Item 5a

Report of the Chief Officer Planning and Regulatory 13 June 2022

APPLICATION NO:
P/2021 /0077

DESCRIPTION:
CODI UNED CYNHYRCHU EGG AM
DDIM ORGANIC A PHOB GWAITH
CYSYLLTIEDIG / ERECTION OF AN
ORGANIC FREE RANGE EGG
PRODUCTION UNIT AND ALL
ASSOCIATED WORKS

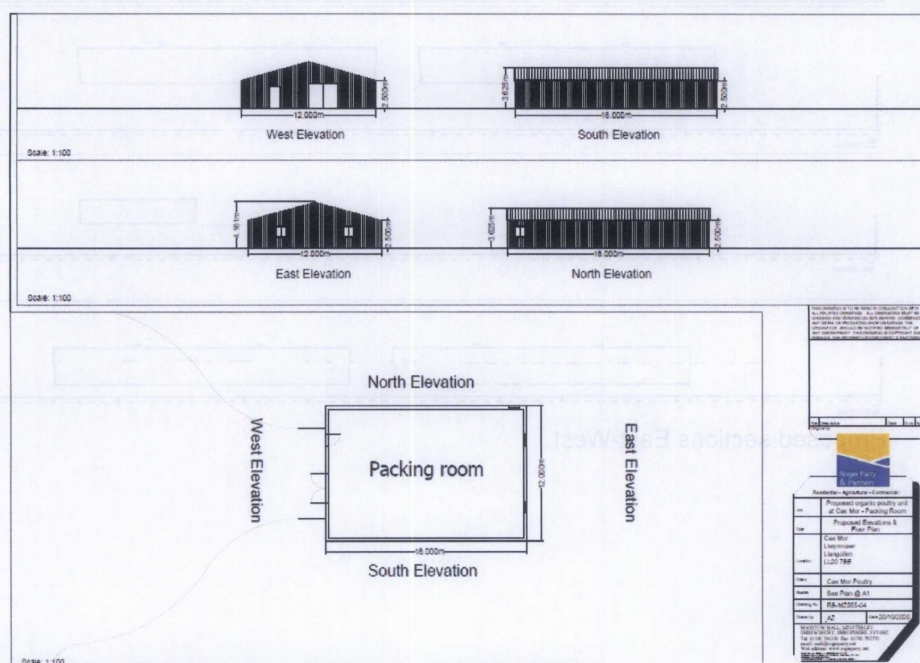
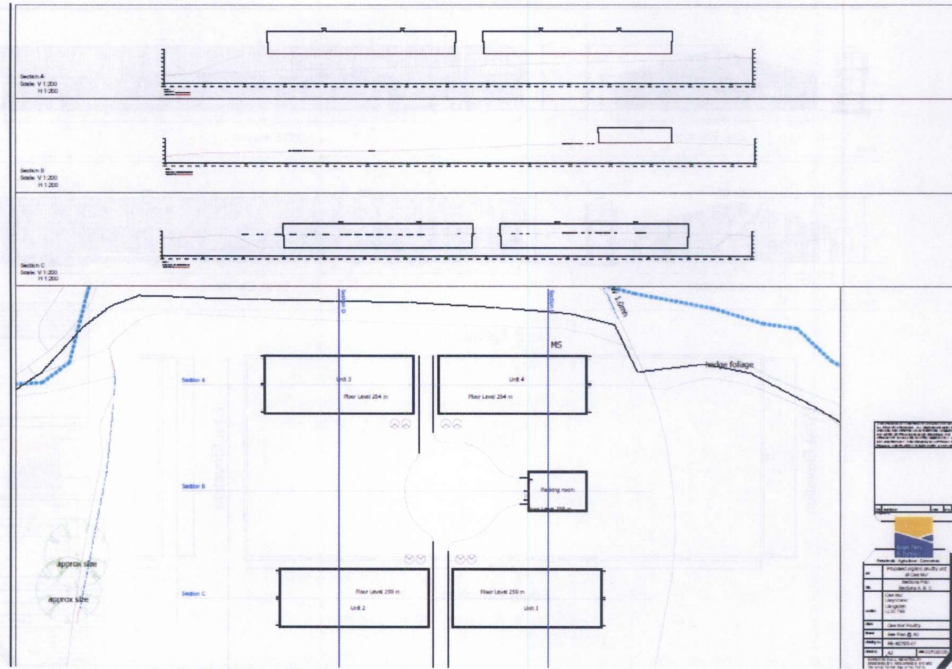
The drawings do not show the position or aspect of the elevator or other equipment which, in Cae Mor 1 is the tallest and most prominent part of the structure.

Proposed sections East-West

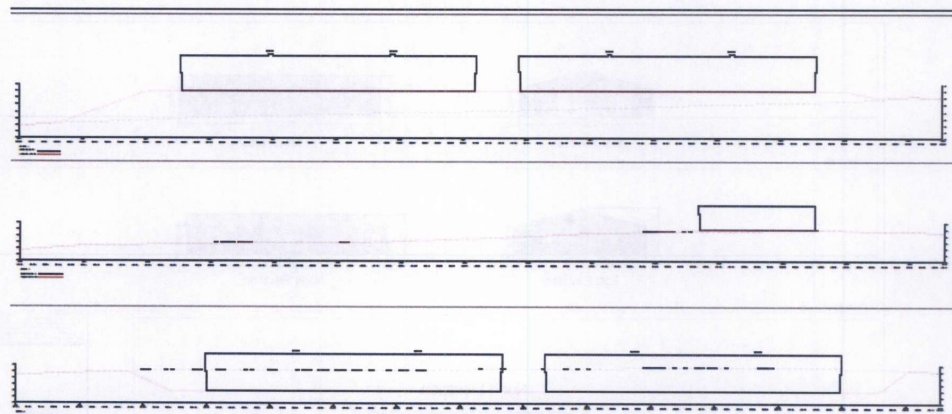
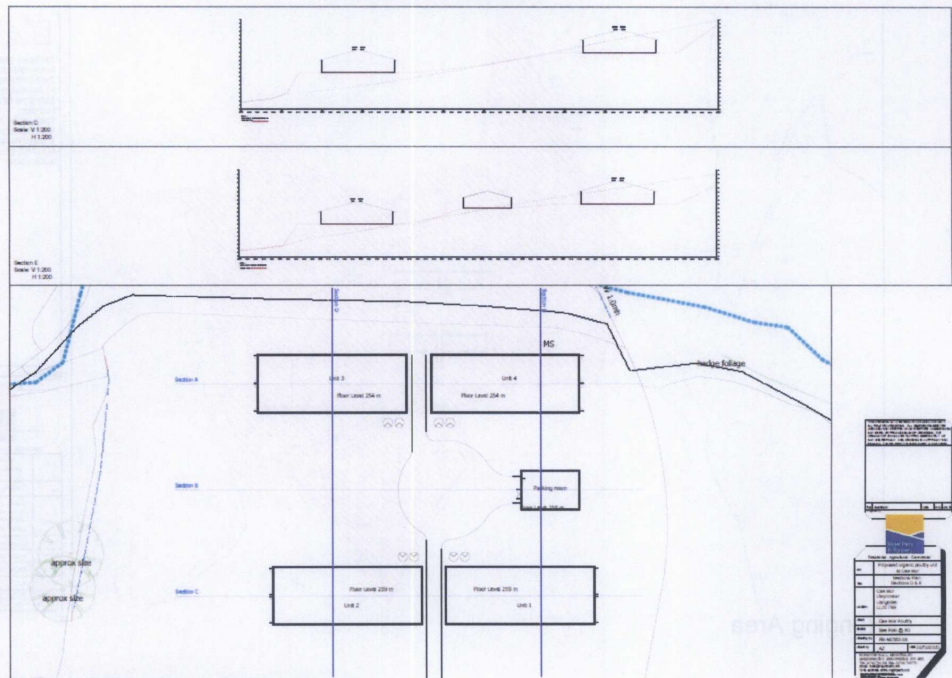
11. Document 4767652 Proposed Sections Sections D and E would seem to indicate that the northern most of the buildings would be built on outcrops making them exceedingly difficult to screen from a northern viewpoint. This needs clarifying as the narrative here and elsewhere identifies landscape and vegetation screening.

Amended landscape scheme showing proposed planting

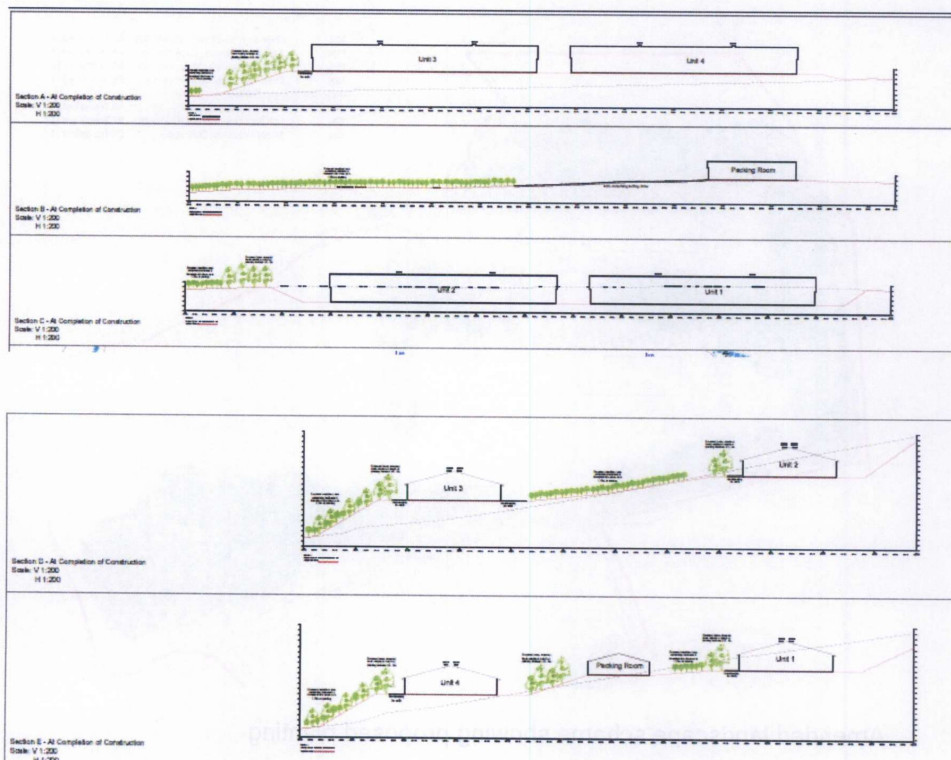
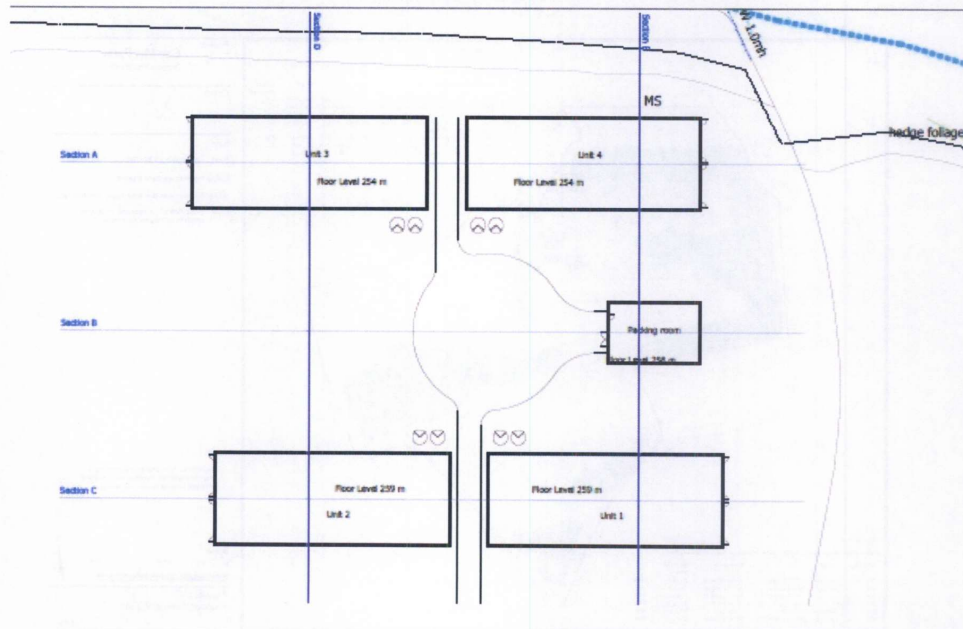
The mitigation offered in the application is the planting of 1.5 hectares of woodland in 5 areas. Whilst this is welcomed, I have two concerns:

1. The length of time taken for the planting to reach some level of maturity, to afford screening, which I would estimate to be 10 years for broadleaved species.

2. The scale of the planting (which is larger than the developed area) is such that it could be regarded as going beyond what is reasonably necessary for the development under the tests for planning conditions as set out in Circular 16/2014. Therefore, an appeal against a condition could succeed.

In response to these concerns the applicant has supplied amended landscape proposals, including the planting of individual extra heavy standard trees between the units and along the route of the public footpath to the north. In addition cross-sections have been supplied showing the impact of the planting after construction and at years 3 and 5 after planting. My concerns over the impact of the development and the limitations of the tree screening remain.
